From: <Terrill.Garland@kidde-fenwal.com>
To: "Jonathan Rivera" <JXR4@nrc.gov>
Date: 3/25/05 3:54PM
Subject: Re: SSD review for new Model No. 7054, Certificate No. NR-668-D-101-E

Deficiency Issues To Address / Clarifications Needed
Kidde Fenwal, 04-58, NR-688-D-101-E

No.	DATE	DESCRIPTION	REV.	CHK.	APP.	TITLE:
						IONIZATION SMOKE DETECTOR
						7051 DETECTOR ASSEMBLY
						DWG. NO. AF30404000
						NOHMI BOSAI LTD.

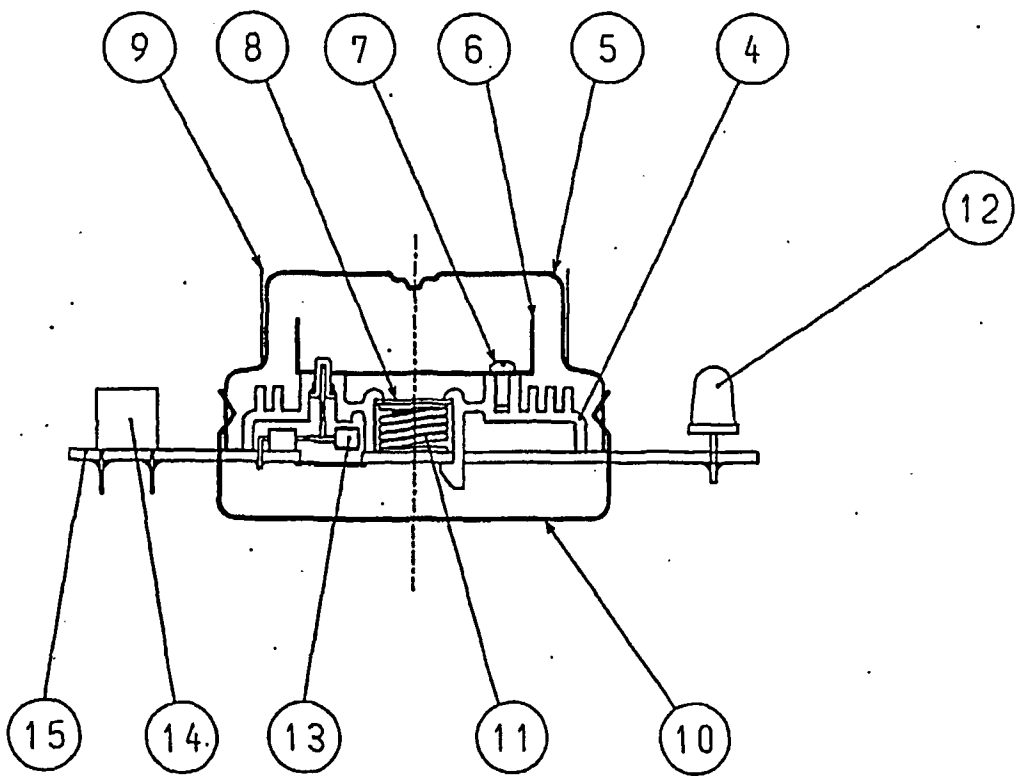
In your application, under the Detector Assembly drawing, Appendix B, you indicate screws under Item Nos. 15 and 16. Please indicate whether or not these screws are tamper resistant, and/or describe how access to the source is prevented.

(These are standard screws, which only hold on the plastic enclosure. The steel Outer Chamber, item No.5, which is soldered to the PC bd., prevents access to the source.)

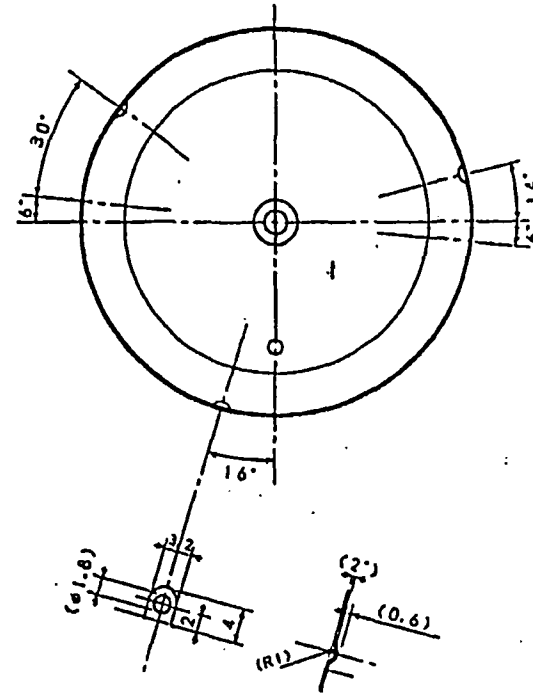
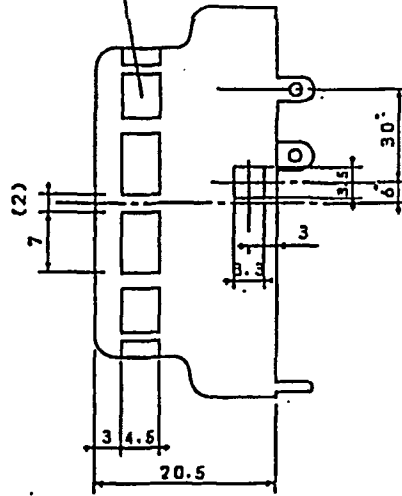
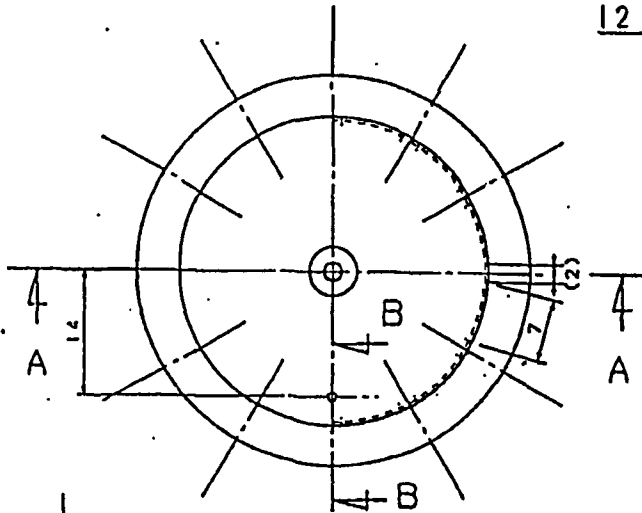
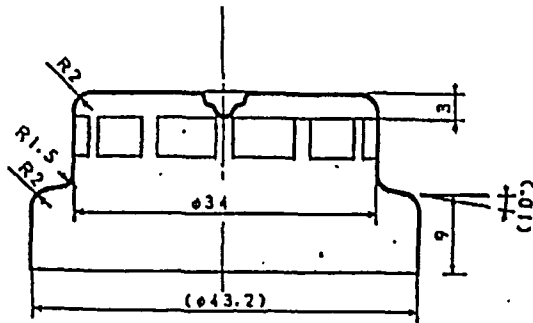
Required Tests in OECD/NEA 1977	Addressed In 9/17/04 Application? (Yes, No)	Comments
Preliminary Tests	General inspection noting obvious defects	No	Provide information (The Outer Chamber, Item 5 on dwg. AF30404100, covers the radiation source and is soldered to the PC bd. This is the same construction as the currently approved Model No. CPD-7051).
	Measurement of external dose rates (averaged over 10 cm ²)	Yes (see comments)	Provide the equipment used and how the average over 10 cm ² is addressed (Currently waiting for our manufacturer in Japan to supply this info.)
	Measurement of radioactive contamination	No	Provide information on wipe tests (The results of the wipe test, which was performed after JRIA Drop Test 2.2, were "Under detection limit" of 1.20Bq, as described in sec. 3.2.b of JRIA Test Report)
